APPENDIX B – RESPONSE TO AGENCY SUBMISSIONS

NSW Department of Planning and Environment

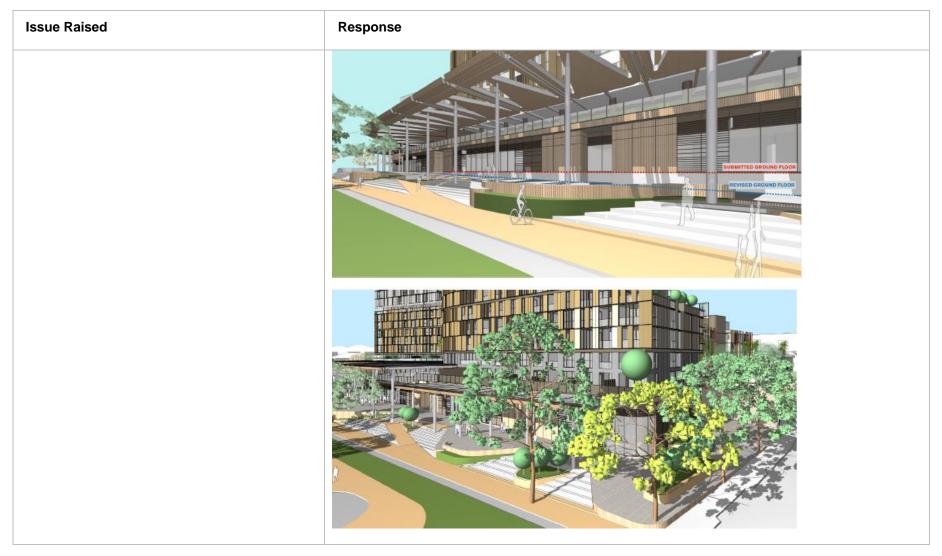
The Department does not support the proposed height of the western building (Building D-J) as it	The height of Building D-J located along the park frontage has been reduced between three – four storeys to a maximum height of 10 storeys above the two storey podium.
is incompatible with the site's context, does not provide an appropriate height transition to	The following provides a summary of the updated assessment of the proposal.
neighbouring sites and would result in adverse	Overshadowing
visual and amenity impacts. As such, the Department requests that the overall height of the building be reduced.	Overall, the proposal provides significantly greater solar access to Eastlakes Reserve during mid- winter compared to the approved development by approximately 50%. Between 11am and 3pm at mid-winter the proposal provides unimpeded solar access to Eastlakes Reserve.
	In summary, all the buildings in the immediate context of the proposed development will receive in excess of two hours of solar access on 21 June.

View Impact Assessment
	An updated View Impact Assessment has been undertaken. 10 key viewpoints were identified and a comparison analysis between the existing centre, the approved development, the exhibited development, and the Preferred Project was undertaken.
	The analysis demonstrates that although the Preferred Project scheme increases visibility of the centre, this heightened visibility provides a key wayfinding and legibility marker to both pedestrians

Issue Raised	Response
	and motorists in the 800m catchment of the site. The analysis demonstrates when viewed from 800m, the proposed built from, although visible, sits within the overall composition of other elements in the skyline, both built and natural.
	The analysis also demonstrates that the reduction of three – four storeys in the Preferred Project provides an improved response to the local context. Furthermore, View 8 from St Helena Parade is the only view that the developments building envelope maintains a particularly prominent presence. However, the building quickly recedes beyond it and cumulatively there is a substantial reduction in visible building form compared to the 2018 exhibited scheme.
	Urban Context Analysis
	As outlined in the Urbis urban context analysis, the scale of the development is considered appropriate given the shopping centre is the 'central or focal point' of the locality, and the massing will positively mark the location of the centre. Whilst this will become the tallest development in the centre, the locality is characterised by a mix of building forms that include residential flat buildings and larger towers and thus the proposal in our assessment does not create a discordant relationship to the existing surrounding context.

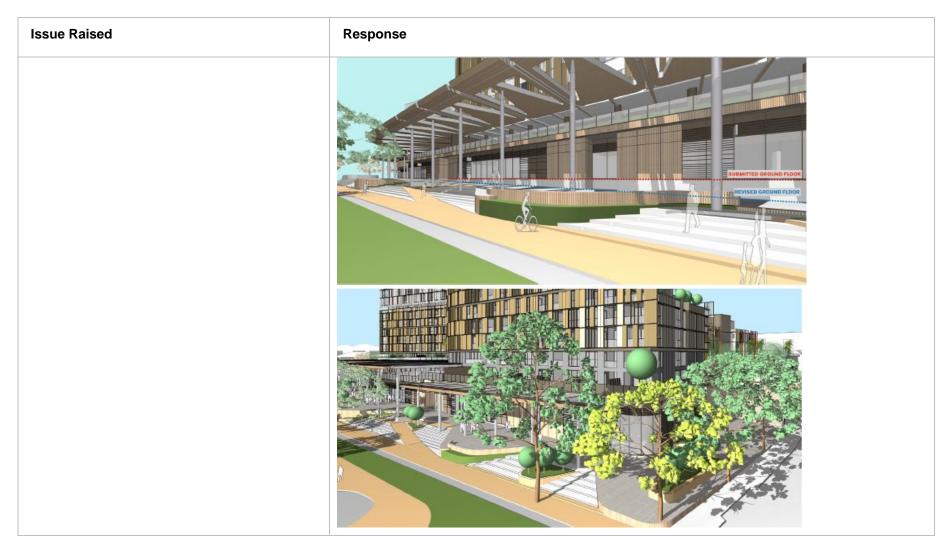
Roads and Maritime Services	
SIDRA modelling required to verify at the proposed increases in trip generation will have a negligible impact to the network. Reference is made to the SEARS which requests an assessment of key intersections, and confirmation that both the right turn bay and left turn slip lane on Gardeners Road into Racecourse Place will not be affected.	CBRK have amended the Traffic Report and updated the SIDRA modelling. In terms of traffic impacts the amended Traffic Report concludes that the proposed modification results in a mode increase in traffic generation and is therefore considered to result in negligible additional traffic impacts. The report concludes that as a result of the proposed modifications sought by the amended application, the surrounding road network and intersections will continue to operate at satisfactory levels of service during peak periods consistent with the approved development.

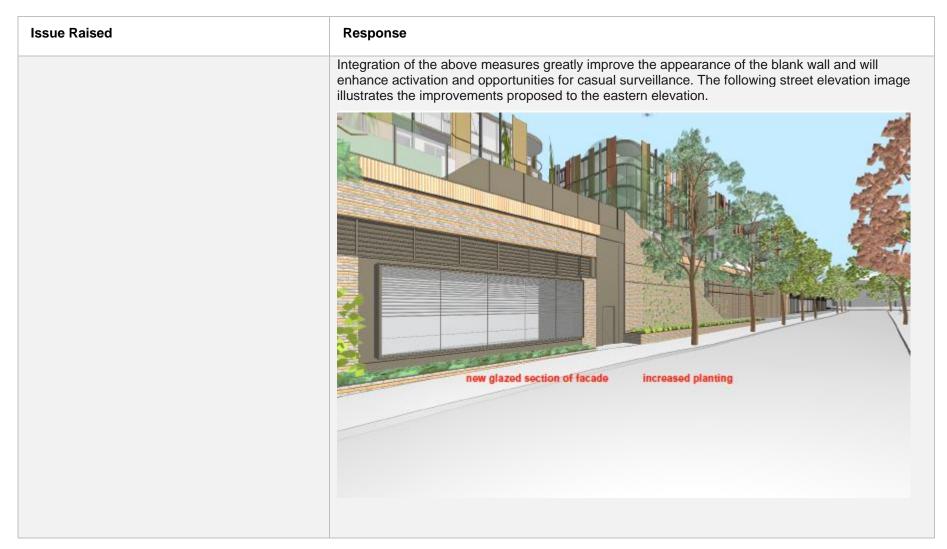
Issue Raised	Response
The design of the junction at Evans Avenue should be amended to improve its function and address safety concerns	Refer to responses about this issue above.
Reducing the bulk and scale of Building J and increasing the separation between Buildings D and J would improve internal privacy and amenity and reduce the visual impacts associated with the proposal.	The bulk, scale and height of Building D and J have been substantially reduced, as documented in the RtS and PPR and discussed throughout this table. The separation distances between Building D and J are now ADG compliant as discussed at Section 4.3.1 of the RtS and PPR.
The proposal should be amended to improve the residential amenity of the apartments.	The amended scheme is now fully ADG compliant in terms of solar access and cross ventilation. Supporting diagrams are included within the drawing set that forms part of this submission. Reference is also made to the Design Report at Appendix E which documents the proposals consistency with the design criteria contained in the ADG.
